f. ALT-1 IS ACCED IN DETS DRG NO ALT NOTE NO 5
SIGNATURE COLUMN (ALT-1)
DESIGNATION | SIGNATURE
DFM/DHC (RAIL/ANC) | Shailesh Kumar Meena Sr. Divisional Engineer (Co-ordination) Danapur
STM/DHC (SIGNAL/ANC) | Ajay Kumar Sr. Section Engineer (Signal) Danapur
ASSTT. MANAGER (SIGNAL/ANC) | Ajay Kumar Assistant Manager (Signal) Danapur
SR DOM/DHC/DNR | Ajay Kumar Sr. Divisional Operations Manager Danapur
SR DSTE/DHC/DNR VNE | Ajay Kumar Sr. Divisional Signal & Telecom Engineer Danapur
GRADE POST FOR UP MAIN LINE
GRADE POST FOR DN MAIN AND PRO. REVERSIBLE LINE
GRADE POST FOR DN MAIN AND UP MAIN LINE
GRADE POST FOR UP MAIN LINE
KEY PLAN
NOT TO SCALE
SCALE:- 1:1000
पूर्व मध्य रेल
EAST CENTRAL RAILWAY
DHANBAD DIVISION
PROJECT EXECUTED BY:-
RAIL VIKAS NIGAM LIMITED
PROJECT:- महत्व से काम के लिए हमारी वचन प्रतिबद्धता
QUALITY IN EVERY WORK
CONSTRUCTION OF 3RD LINE BETWEEN PATRATU - SONNAGAR
TITLE:-
RAY(ITU STATION YARD PLAN AT Km 150.050

(TRADE) PLANS
CE'S/RYPI DRG No :- 1 R1- 2021 (ALT-1)
AUTHORITY OF WORK :- Pink Book Item
No. 2019-20
PCN/ETL DRG.NO.:- RVNL/RNC/2021/35
Signature block
DFM/DHC (RAIL/ANC) — BRIJESH KUMAR PANDEY Divisional Engineer (Co-ordination) Dhanbad
STM/DHC (SIGNAL/ANC)

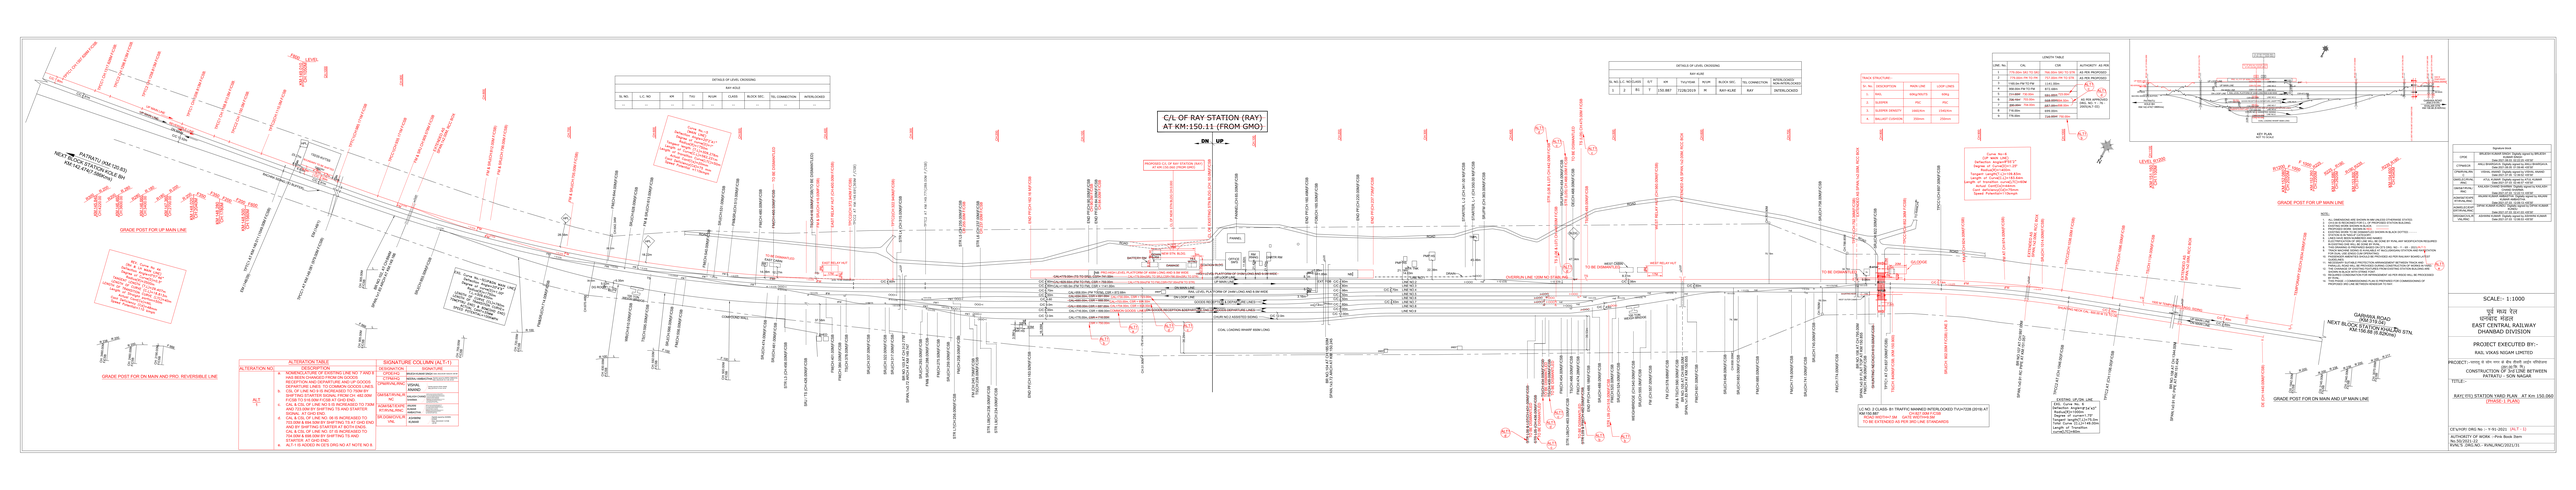
5 | 314.98M (M5 DN) | 283.00m (M5 DP) | AS PER PROPOSED
6 | 356.76M (M6 DN) | 368.80M(M6 DN) | AS PER APPROVED
7 | 356.76M (M7 DN) | 368.80M(M7 DN) | AS PER APPROVED
8 | 356.76M (M8 DN) | 368.80M(M8 DN) | AS PER APPROVED
9 | 776.00m | 726.80M (M9 DN) | AS PER APPROVED
ALTERATION TABLE
ALTERATION NO. | DESCRIPTION
ALT-1 | a. "MOMENTARY CHARGE OF SYSTEM (IN NO '3 'AND 5 'MAN BOARD CHARGE OF SYSTEM ON LOCRO - RECEPTION AND DEPARTURE AND UP GOODS DEPARTURE LINE" IS INCREASED TO 70 (SEVENTY)

b. C/L OF LINE NO 5 IS INCREASED TO 70(M-PP-SHIFTING STARTER SIGNAL FROM CH: 492.60M TO 70.47.60M) AND 72(M-PP-SHIFTING
c. C/L & C/L OF LINE NO 5 IS INCREASED TO 73(M AND 72(0.60M BY SHIFTING TO AND STARTER SIGNAL FROM CH:

d. C/L & C/L OF LINE NO. 06 IS INCREASED TO 703.30M & 694.30M BY SHIFTING TO AT GND END SIGNAL FROM CH: 492.60M TO 703.30M
e. C/L & C/L OF LINE NO. 07 IS INCREASED TO 704.30M & 698.00M BY SHIFTING TO AND STARTER SIGNAL FROM CH:
